Access Compliance Report Public Rights-of-Way (Pedestrian Signals)

Main Street: LOS Alamitos Blvd Cross Street: Bradbury Rd Location: SE

ADA ID: SGRK211221111326 Signal Type: One Push Button-Non APS Overall Compliance: No Severity Scores: BTN 1: 35 BTN 2: N/A No BTN: N/A

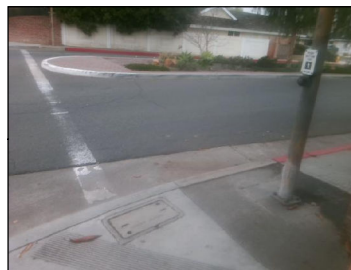
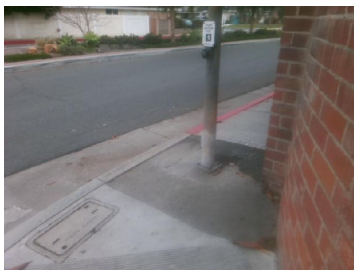
OC Std/PROW: MUTCD 4e.08, R404.2, R404.3

Possible Solutions: Replace Signal Push Button With APS Button. Remove & Relocate Sign.
